Product Change Notification

Change Notification #: 117118 - 00
Change Title: Adding Desiccant Pouch for small shipping box,
PCN 117118-00, Transport Media,
Adding Additional Desiccant Pouch for small shipping box for Tray products only
Date of Publication: August 16, 2019

Transport Media

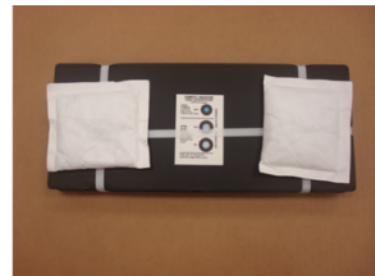
In order to address the marginality of coloration displayed on the Humidity Indicator Card (HIC) of desiccant packed products, Intel will be adding an additional desiccant pouch. The additional desiccant pouch is exclusively for all products that are Tray packed and shipped in a small box.

As a result of adding the additional desiccant pouch, the placement of the HIC will be moved to a new location. For Tray stacks, the desiccant pouches will be placed at each end and the HIC will be placed in the middle.

The change will apply to all Tray packed parts. In short, if products today are being shipped in Tray media in a small box and include a desiccant pouch, customers will now see the use of two desiccant pouches instead of one, with the HIC placed in the middle.
